## ADDENDUM NO. ONE (1)

SIGN-IN SHEET for ITB#6- 2016/2017 GCSC SOFTBALL COMPLEX PROJECT

SHEET TITLE:  
SECTIONS AND DETAILS

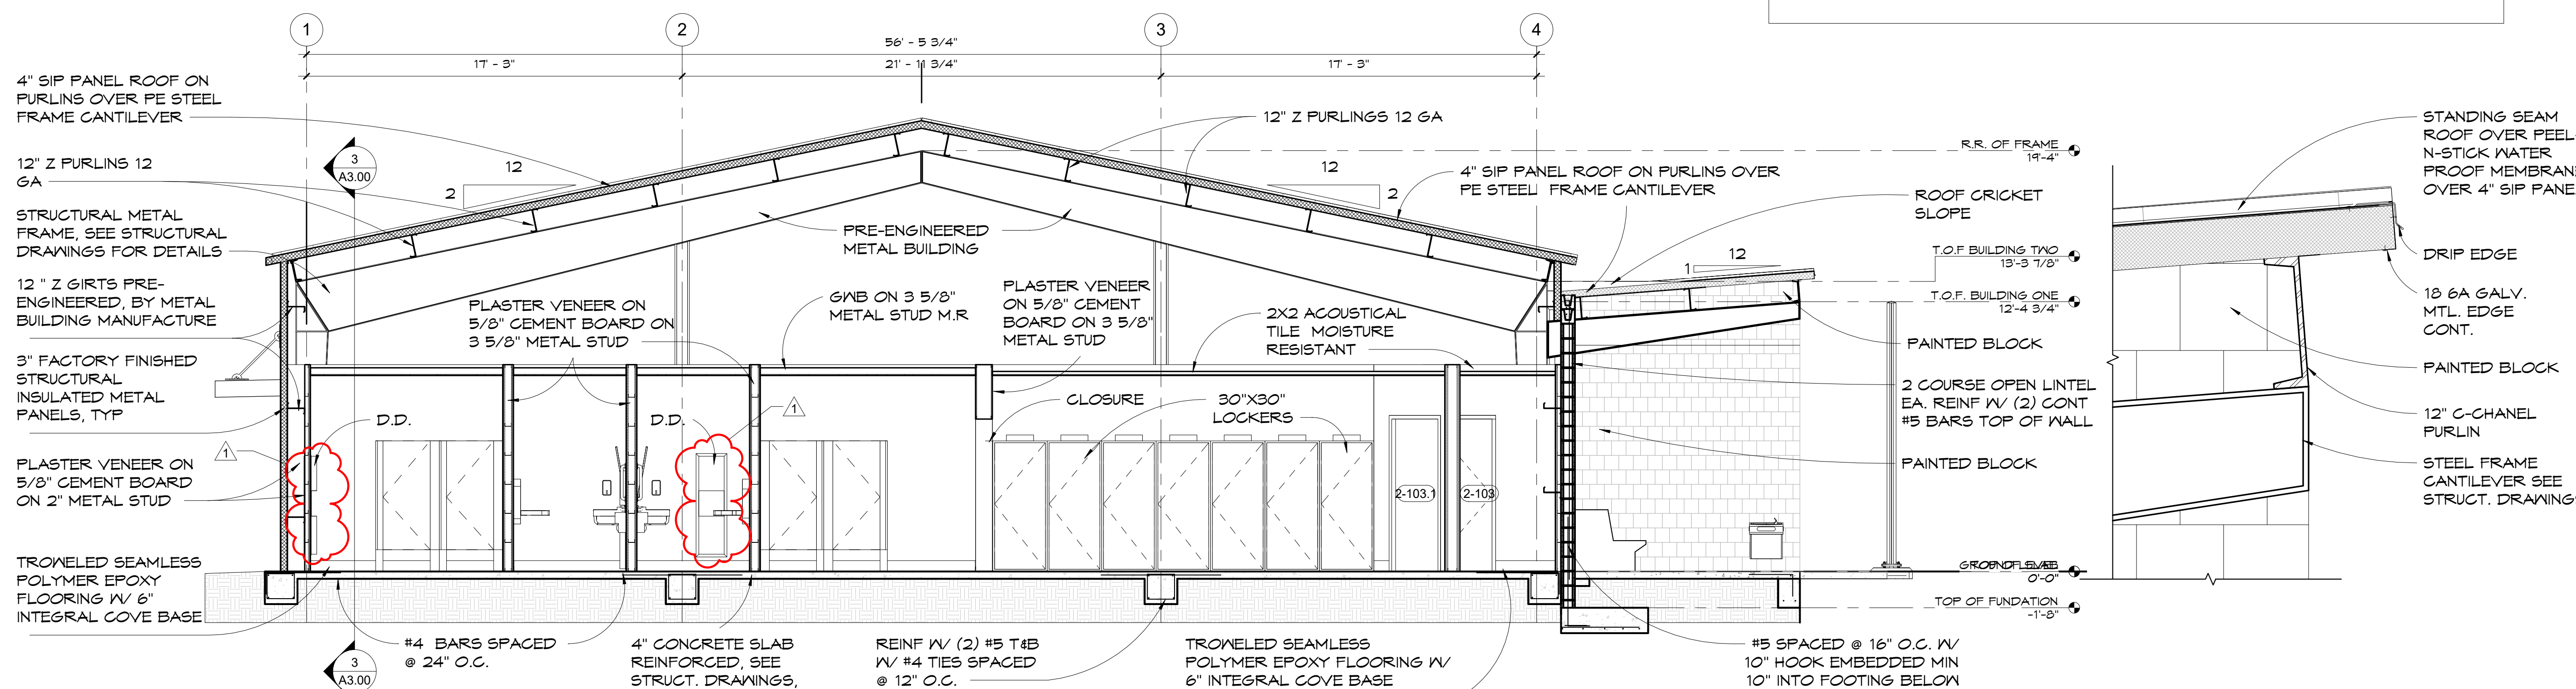
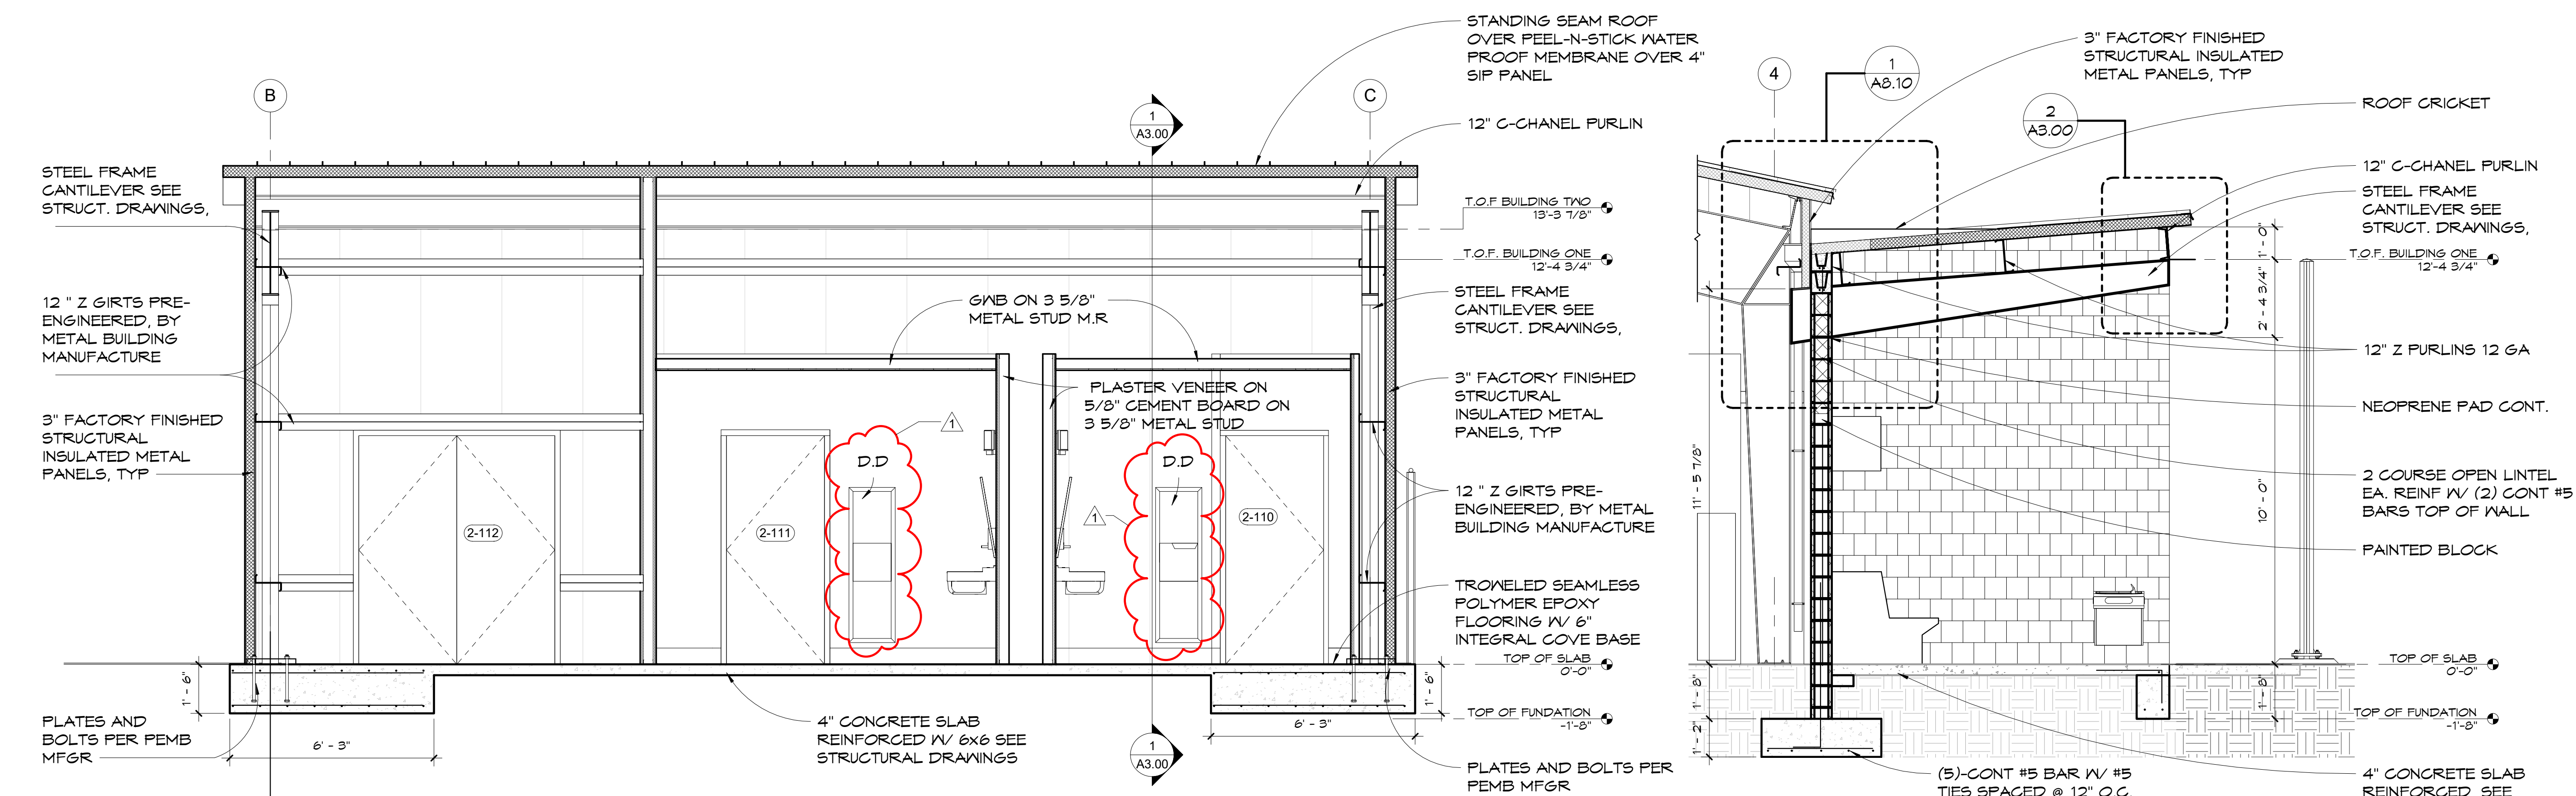
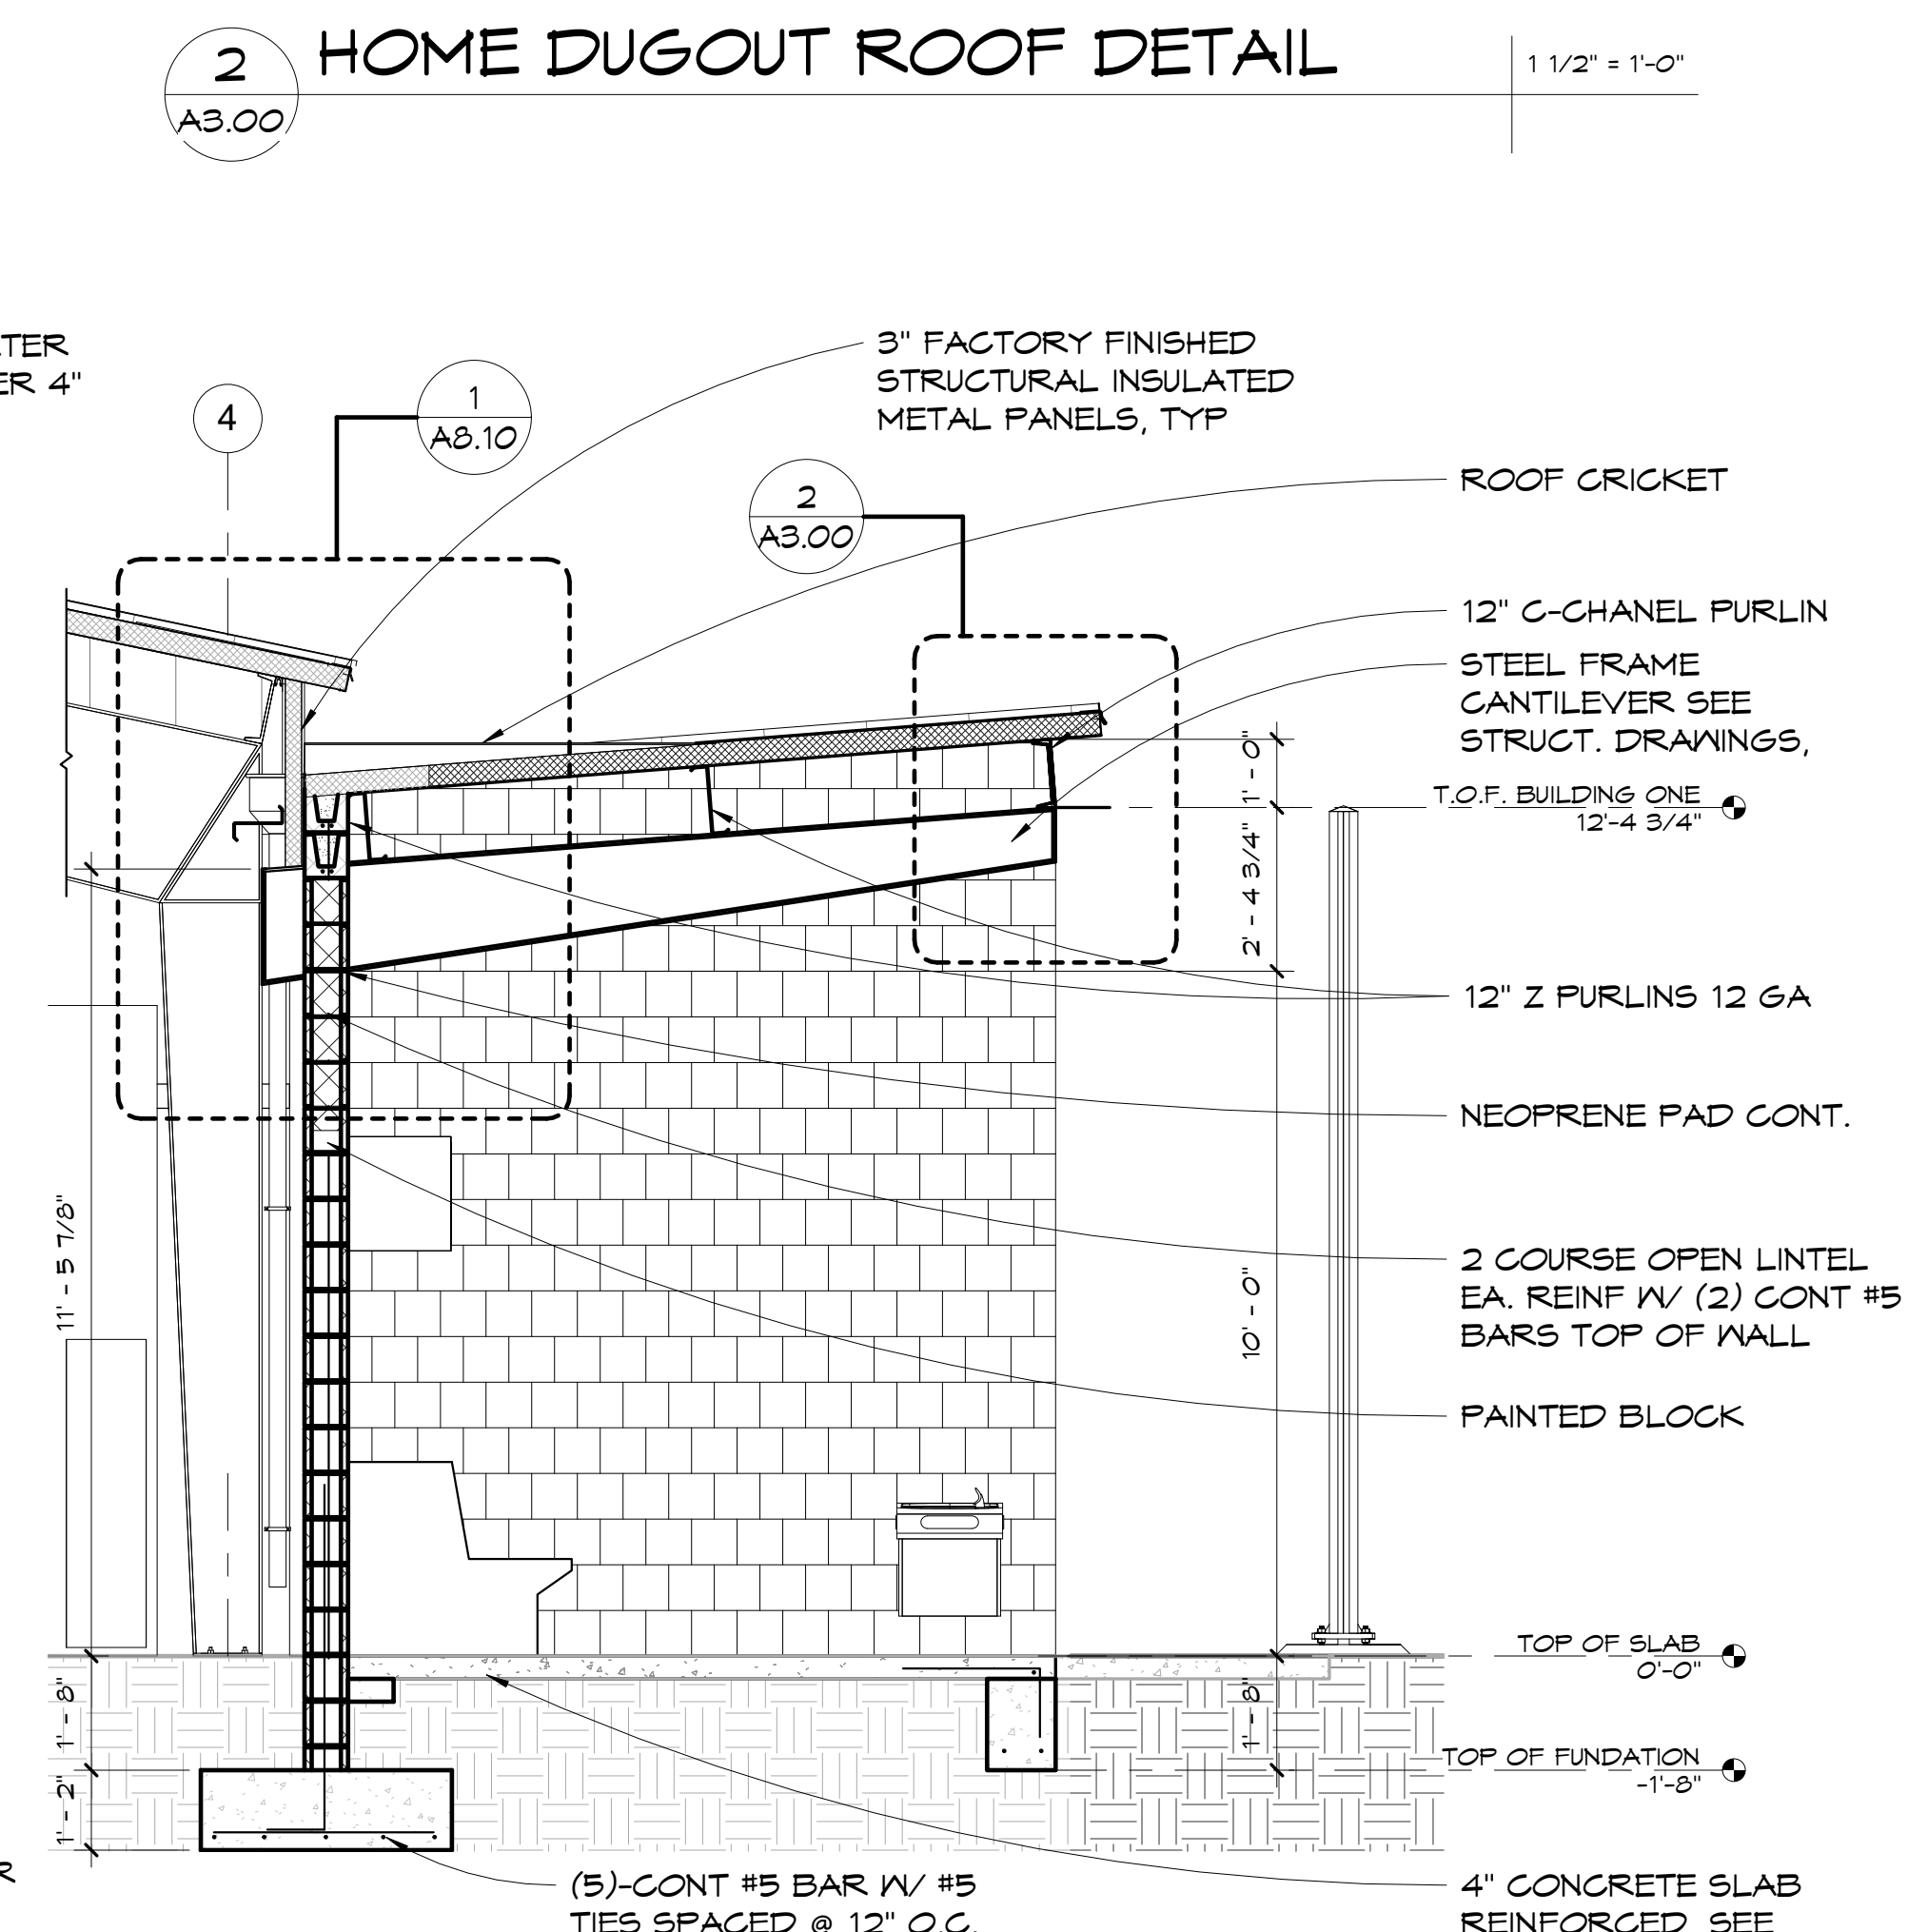
Item No. 7A: Refer to Drawing Sheet A3.00, Sections And Details - **DELETE** H.D.'s (Hand Dryers). Notes with respect to the Metal Building Manufacturer were modified (DELETE "By Others"). Metal Building to be by Contractor.
